Access Compliance Report

Public Rights-of-Way

(Pedestrian Signals)

Intersection ID: N/A	Main Street:	Cross Street: N/A	Location: N/A
ADA ID: BBD556853F33	Signal Type: One Push Button-Non APS	Overall Compliance: No	Severity Score: BTN 1: N/A BTN 2: N/A No BTN: N/A
Codes/Mitigation Info/Possible Solution		Field Measurements/Component Compliance

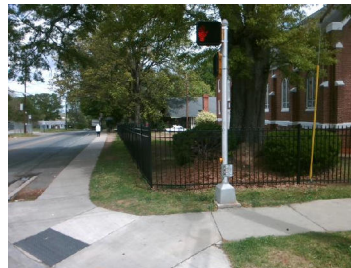
PROW/ADA: TMUTCD 4e.08, R404.7.2

N/A	B 1 FWD Approach Width (in)	N/A	N/A	B 2 FWD Approach Width (in)	N/A
N/A	B 1 FWD Approach Obstruction?	Yes	N/A	B 2 FWD Approach Obstruction?	N/A
N/A	B 1 FWD Approach Obstruction Dist (in)	5.0	N/A	B 2 FWD Approach ObstructionDist (in)	N/A
N/A	B 1 PARA Approach?	Yes	N/A	B 2 PARA Approach?	N/A
N/A	B 1 PARA Approach Constrained?	Yes	N/A	B 2 PARA Approach Constrained?	N/A
Yes	B 1 PARA Approach Reach (in)	6.0	N/A	B 2 PARA Approach Reach (in)	N/A
No	B 1 PARA Approach Width (in)	48.0	N/A	B 2 PARA Approach Width (in)	N/A
N/A	B 1 PARA Approach Obstruction?	Yes	N/A	B 2 PARA Approach Obstruction?	N/A
N/A	B 1 PARA Approach Obstruction Dist (in)	6.0	N/A	B 2 PARA Approach ObstructionDist (in)	N/A
Yes	B 1 Clear Floor Space Slope (%)	1.4	N/A	B 2 Clear Floor Space Slope (%)	N/A
Yes	B 1 Clear Floor Space XSlope (%)	1.6	N/A	B 2 Clear Floor Space XSlope (%)	N/A
N/A	B 1 PAR Slope (%)	N/A	N/A	B 2 PAR Slope (%)	N/A
Yes	B 1 Height (in)	35.0	N/A	B 2 Height (in)	N/A

N/A	B 1 Clear Xing Direction?	Yes	N/A	B 2 Clear Xing Direction?	N/A
	B 1 Crossing Direction	To S		B 2 Crossing Direction	N/A
Yes	B 1 DistanceTo XWalk (in)	57.0	N/A	B 2 DistanceTo XWalk (in)	N/A
No	B 1 DistanceTo Curb (in)	97.0	N/A	B 2 DistanceTo Curb (in)	N/A
Yes	B 1 Diameter (in)	2.0	N/A	B 2 Diameter (in)	N/A

Possible Solutions: Replace Signal Push Button With APS Button on New Post. Remove & Relocate Sign.
